Enclosure 3

Technical Specifications Page Changes with Justification

A description of the Technical Specification changes to allow Fermi 2 single loop operation and their respective justification and reasons are given below:

FIGURE 3.3.10-1

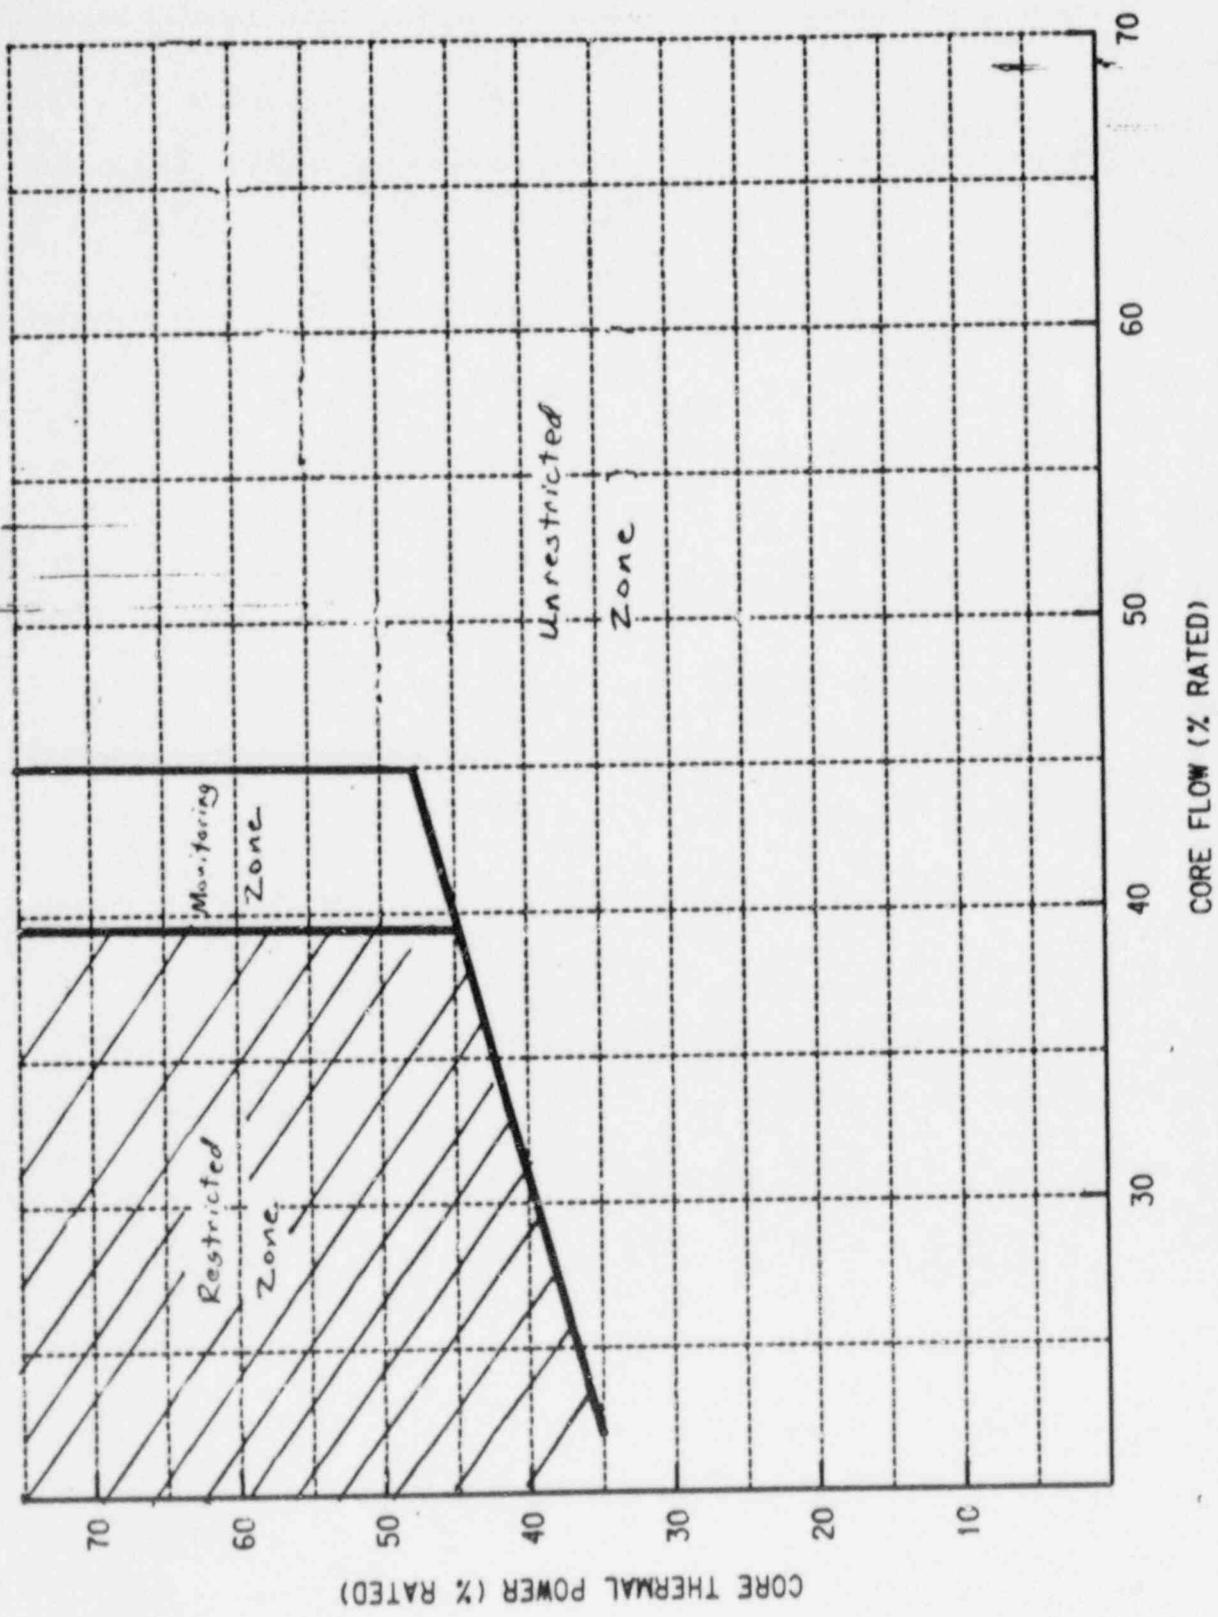
11. New pages 3/4 3-90, 3/4 3-91 and 3/4 3-92; New Specification 3.3.10.
Consolidated stability related requirements in single specification. Additional requirements for single loop operation are included.

APPLICABILITY: OPERATIONAL CONDITION 1 with THERMAL POWER greater than the limit specified in Figure 3.3.10-1 and total core flow less than 45% of rated total core flow.

ACTION: With the APRM or LPRM* neutron flux noise level greater than three (3) times their established baseline noise levels, immediately initiate corrective action to restore the noise levels to within the required limits within 2 hours or reduce THERMAL POWER to less than or equal to the limit specified in Figure 3.3.10-1 within the next 2 hours.

FIGURE 3.4.1.1-1

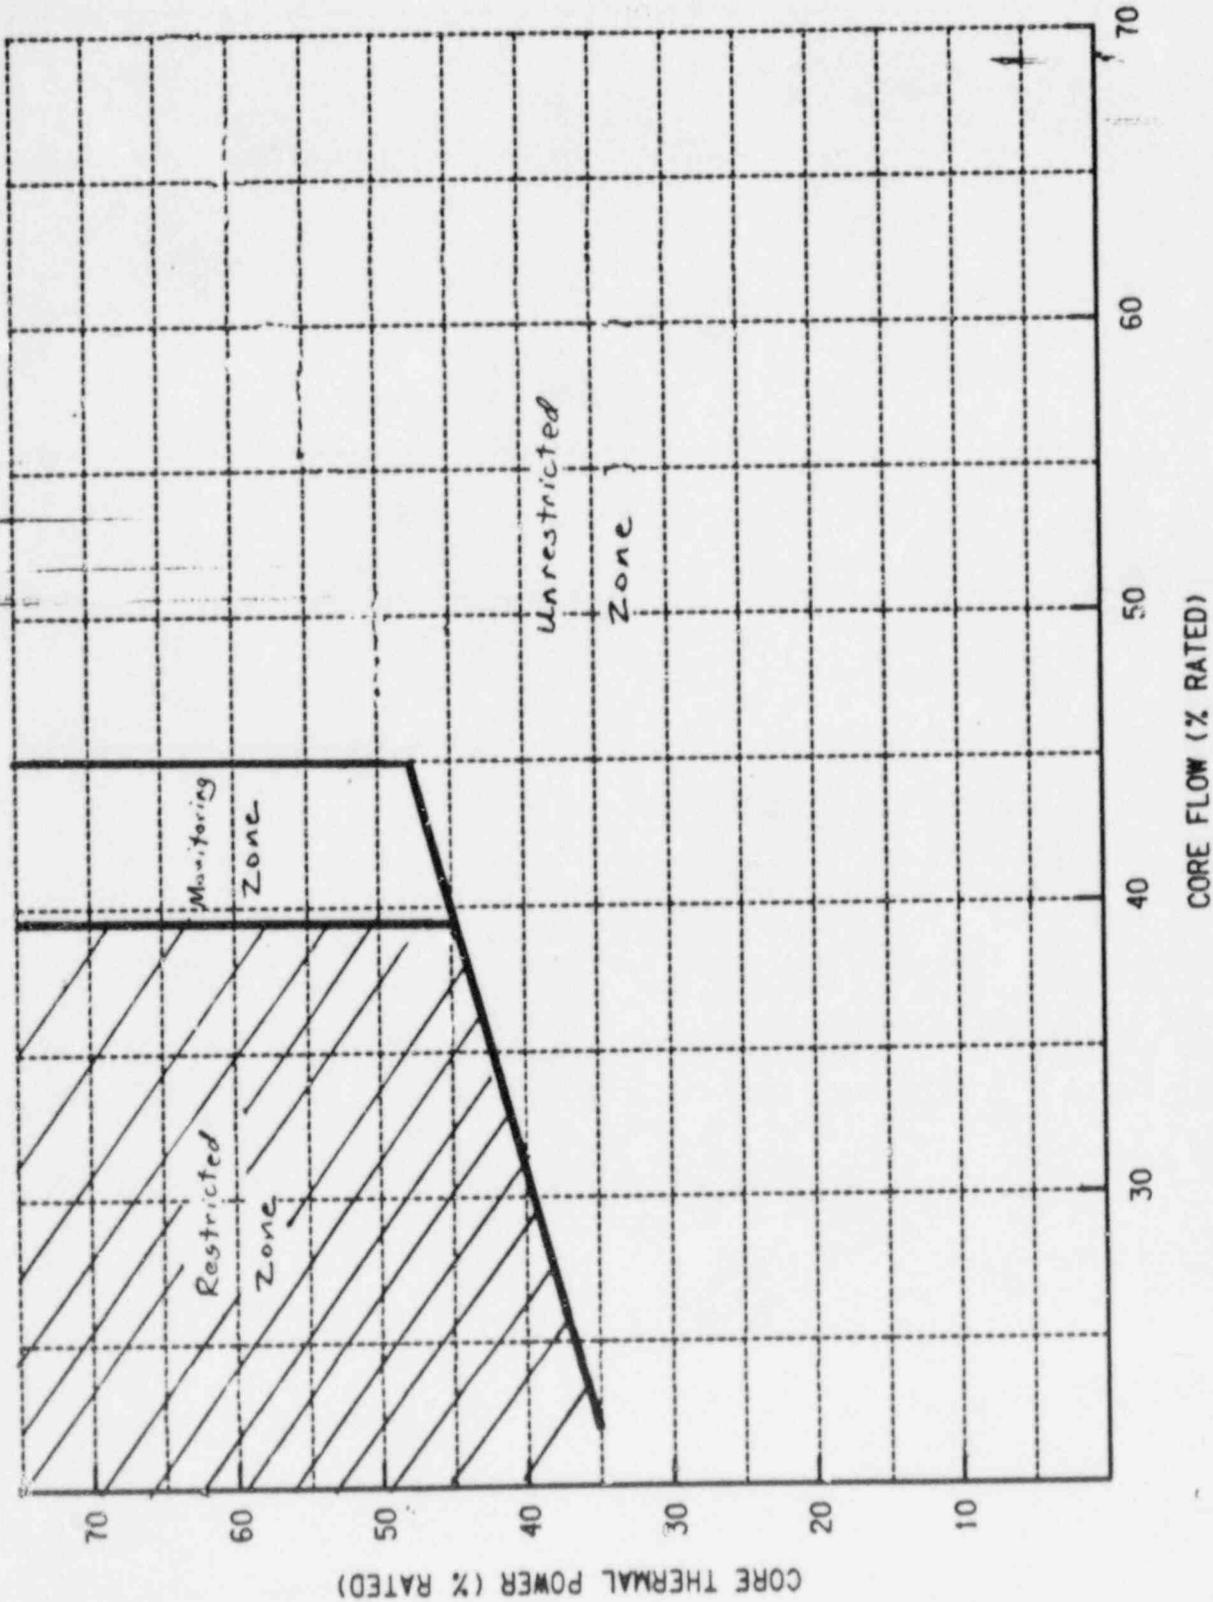
- g) With one reactor coolant system recirculation loop not in operation and THERMAL POWER greater than the limit specified Figure 3.4.1.1-1 and core flow less than 39%# of rated core flow, immediately initiate action to, within the next 4 hours, reduce THERMAL POWER to less than or equal to the limit specified in Figure 3.4.1.1-1 or increase core flow to greater than or equal to 39%# of rated core flow.

- h) The provisions of Specification 4.3.10.3 must be satisfied unless THERMAL POWER is less than or equal to the limit specified in Figure 3.4.1.1-1 or total core flow is greater than or equal to 45% of rated core flow. With one reactor coolant system recirculation loop not in operation and with THERMAL POWER greater than the limit specified in Figure 3.4.1.1-1, and total core flow less than 45% of rated core flow, and the provisions of Specification 4.3.10.3 having not been satisfied, immediately initiate action to, within the next 4 hours, reduce THERMAL POWER to less than or equal to the limit specified in Figure 3.4.1.1-1 or increase total core flow to greater than or equal to 45% of rated core flow.
